Re: Addition to 8361 Modesto NE, Engineer's Stamp dated 10-19-06
Lot 31 Block 17 Tract 1 Unit 3 of North Albuquerque Acres (B20/D16)

LOT 31, BLK 17, TR 1, U3
PLAN PREPARED BY:
BERNARD R. FREEMAN, PE
FOR
GARY SINGER

APPROVED GRADING AND DRAINAGE PLAN - 2002

AREA OF REVISION

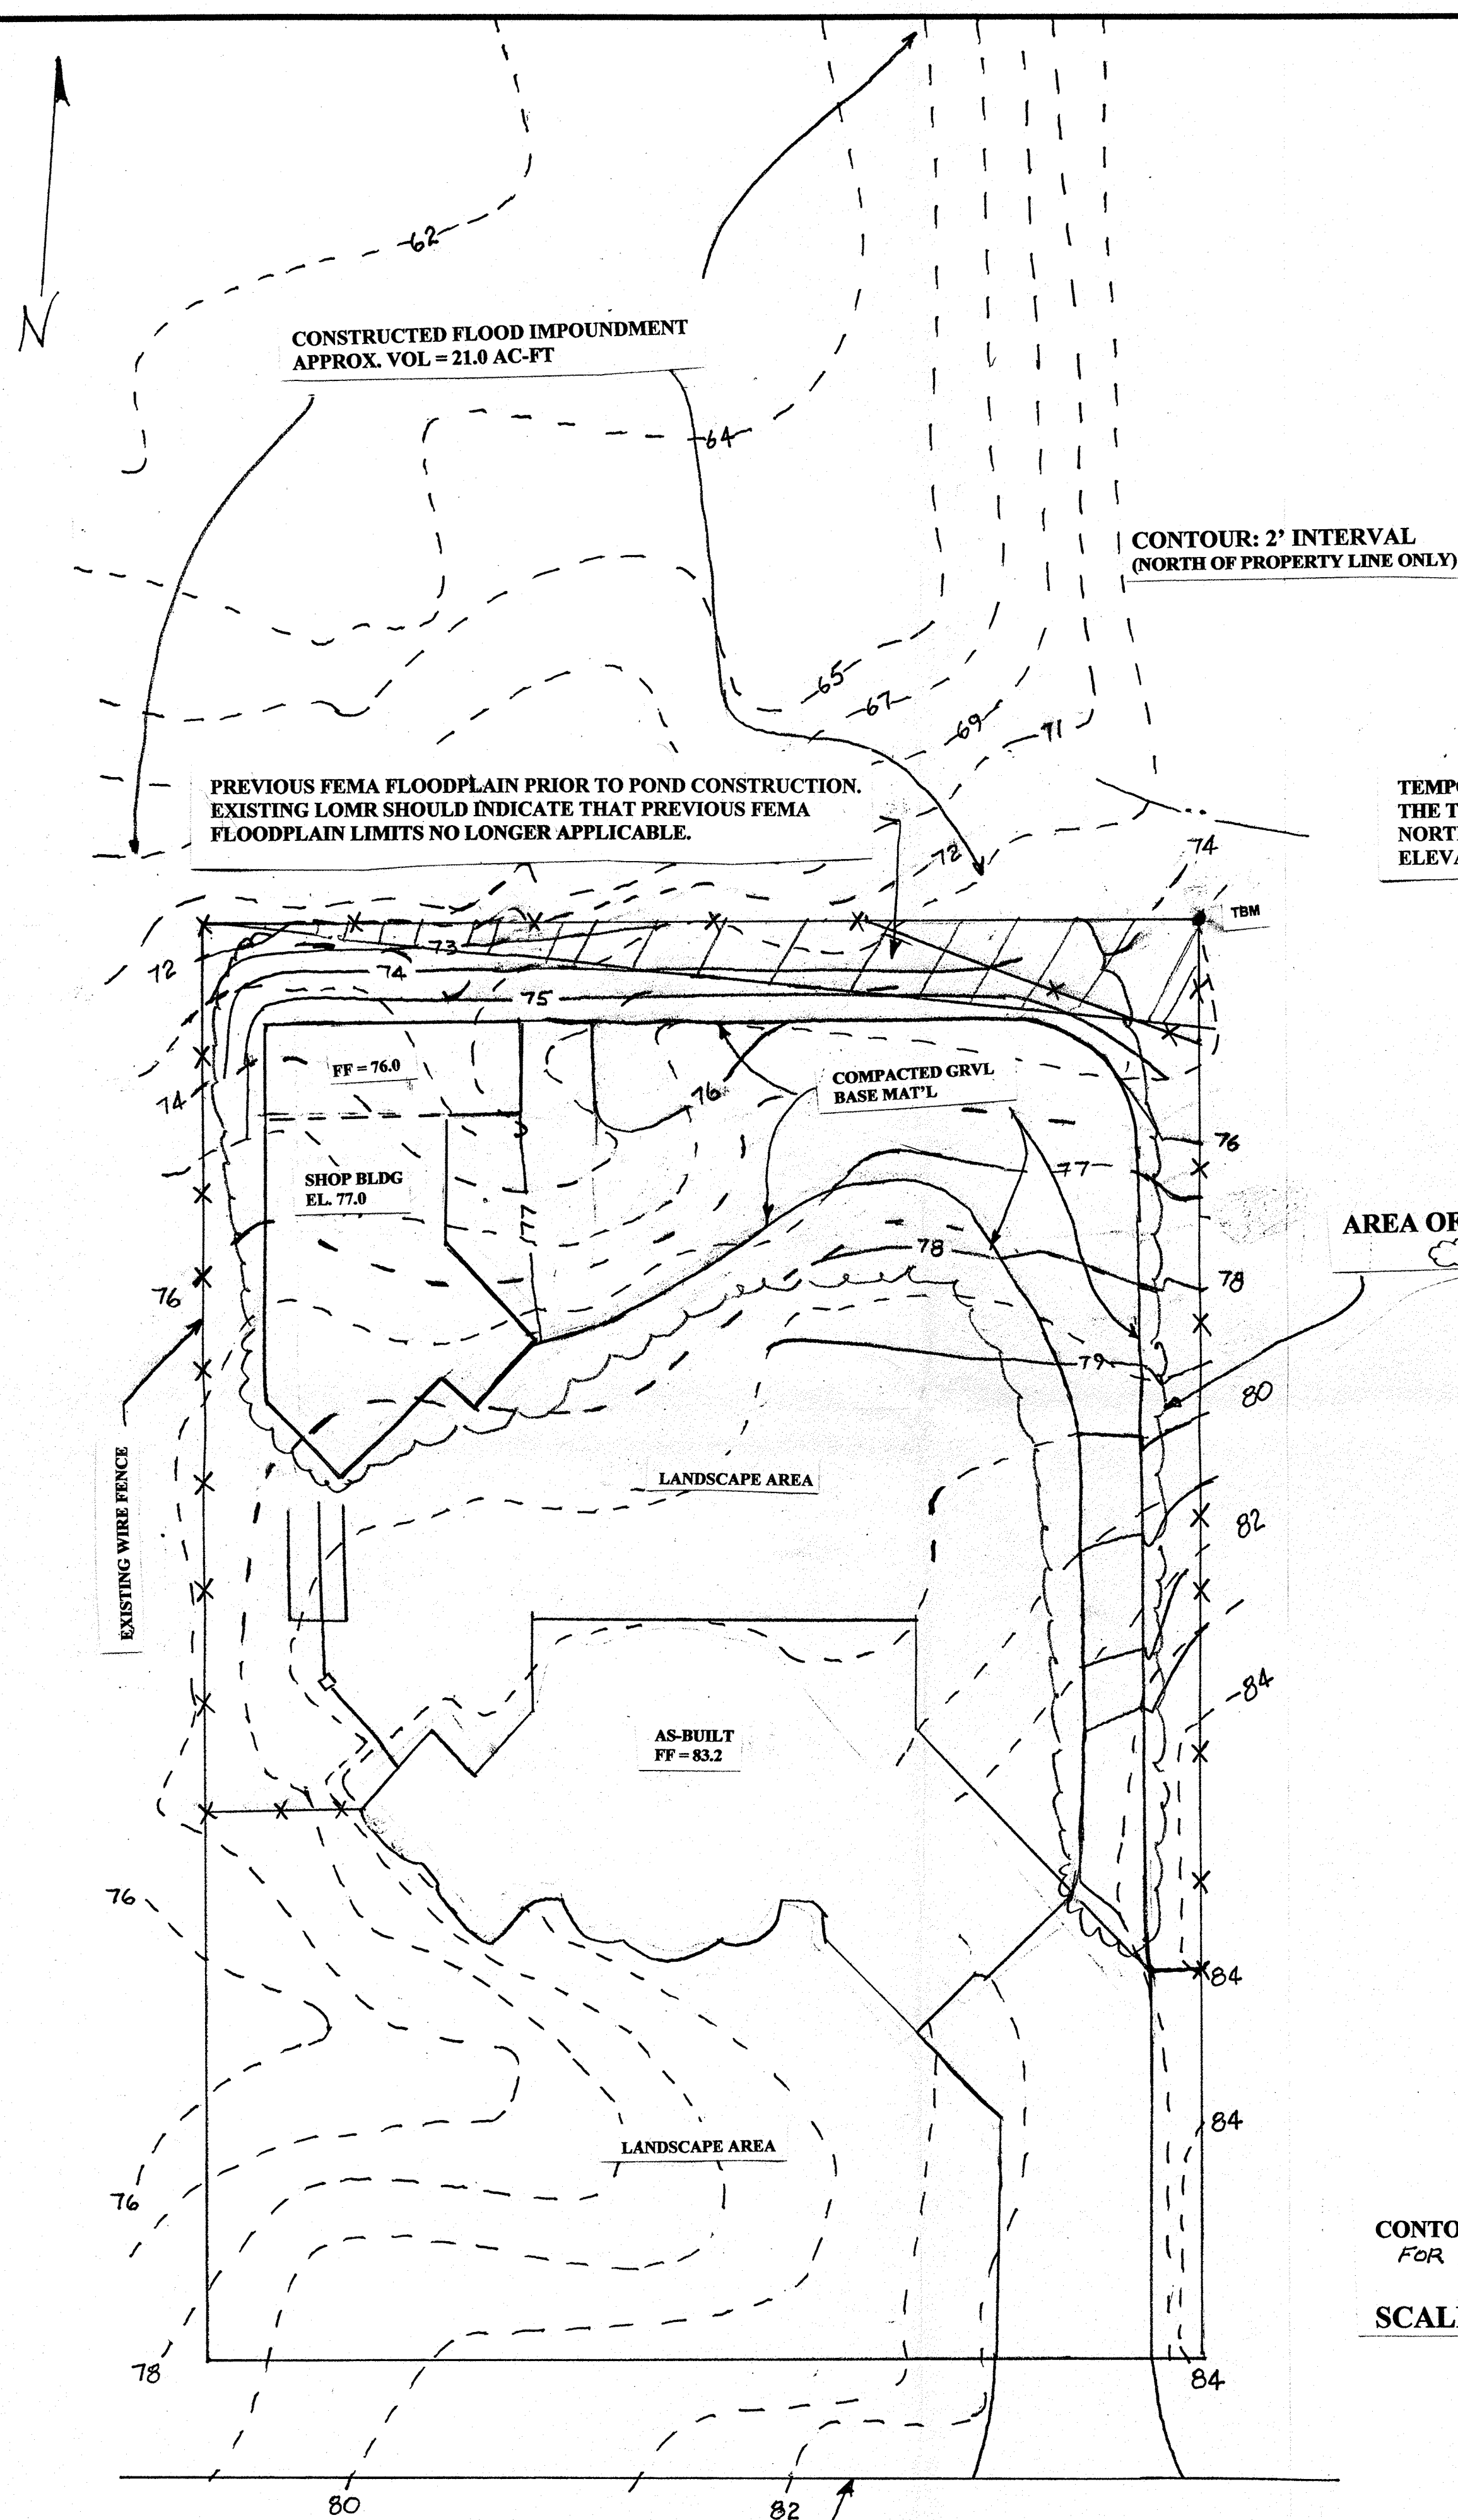
- ① NARRATIVE
- ② REEF FLOW DIRECTIONS?
- ③ DEAL W Q ON WEST SIDE OF LOT
- ④ WALLS?
- ⑤ FIRM MAP?
- ⑥ CALL OUT SPECIFIC LOT TO REMOVE FLOOD PLAIN
